ITEM

Application Reference	DC/082338
Location:	Former Jasmine Thai Restaurant Buxton Road Hazel Grove Stockport SK7 6NA
PROPOSAL:	Erection of 8 no. dwellinghouses with associated infrastructure and landscaping.
Type Of Application:	Full Application
Registration Date:	19/08/2021
Expiry Date:	14/10/2021
Case Officer:	Mark Burgess
Applicant:	Jasmine Hazel Grove Ltd
Agent:	Iceni Projects Limited

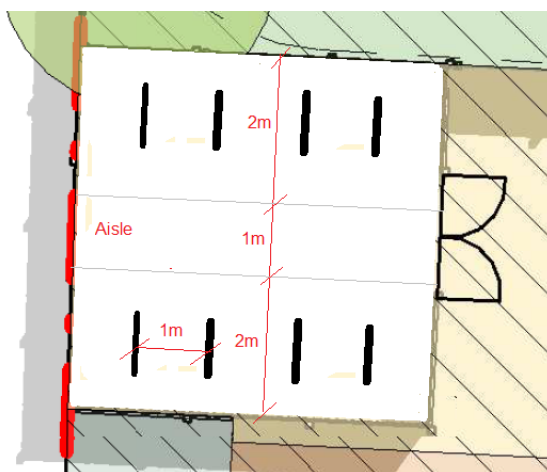
As outlined at the time of the previous application the bus stop outside the site does not presently benefit from a boarding platform or shelter. In addition, I note that the proposed footway abutting the site is shown to be slightly sub-standard in width (footways should be a minimum of 2m in width), there is no crossing point to allow pedestrians to cross Buxton Road in the vicinity of the site and there is no footway along the full length of the site access road (and the road is not designed as a shared surface access road). These issues could prevent / deter occupiers of the dwellings and their visitors from walking and using public transport and mean that the site could not be safely accessed by foot.

The previous scheme included proposals for a 2m wide (min.) footway across the site frontage, as well as an upgraded bus stop and pedestrian crossing point, and I consider that these are still required. Whilst the detailed design of these can be dealt with at detailed-design stage / by condition, the scheme does need to incorporate these and a layout which incorporates these needs to be agreed. As such, I recommend that the scheme is deferred and the applicant is requested to submit a revised site layout plan which addresses these issues. In addition, a Stage 1 Road Safety Audit and Designer's Response must be produced for the works within the highway so as to enable the initial design of these highway works to be reviewed from a highway safety perspective.

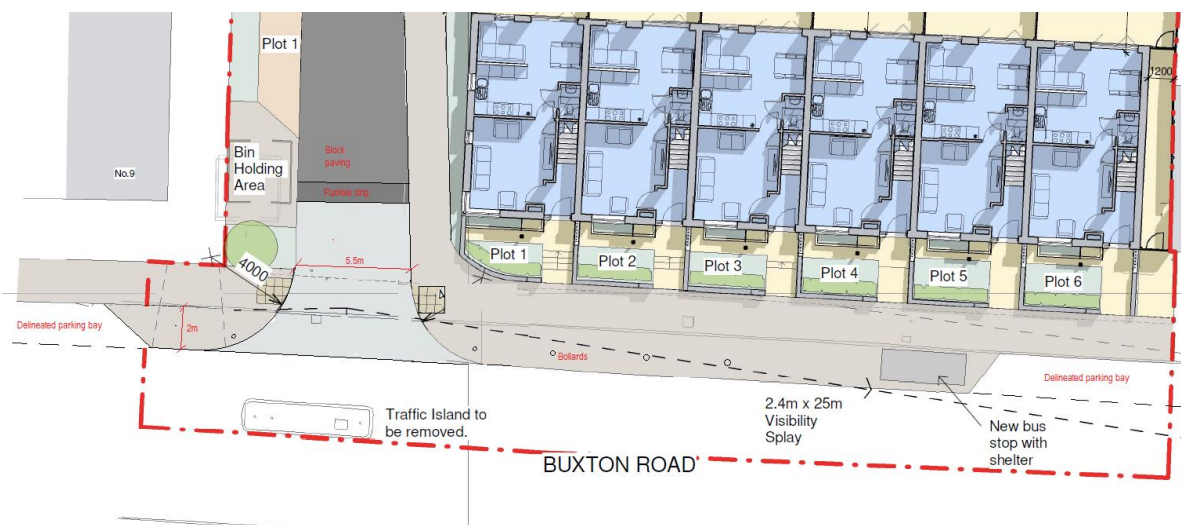
Whilst a cycle store is proposed to be provided, the layout / design of the store would mean that cycles could not be wheeled to / from the stands within the store. This issue, however, could be addressed by widening the store slightly and reconfiguring the stands, as shown on the drawing below.

Access to the cycle store will also be compromised due to the small gap between the spaces for Plots 3 and 5. This could be addressed by moving the space for Plot 3 so it is adjacent to the spaces for Plot 7 in order to provide a wider gap to access the store.

As such, I consider that the layout needs to be revised in order to address these issues. As such, I also consider that the application needs to be deferred to allow the applicant to address these issues. Whilst I can provide the applicant with detailed advice on what amendments are required and should address my concerns, I would advise them to contact me first to discuss possible options. These will be dependent on a number of issues, including whether the applicant may wish to offer the road up for adoption as public highway in the future and whether the access road needs to be accessible for fire appliances (having regard to Building Regulation B5).

As well as the submission of a revised site layout, vehicle swept-path tracking diagrams will need to be submitted to demonstrate that vehicles will be able to negotiate the site access road and a Stage 1 Road Safety Audit and Designer's Response will need to be produced so as to review the design of the access road from a highway safety perspective.
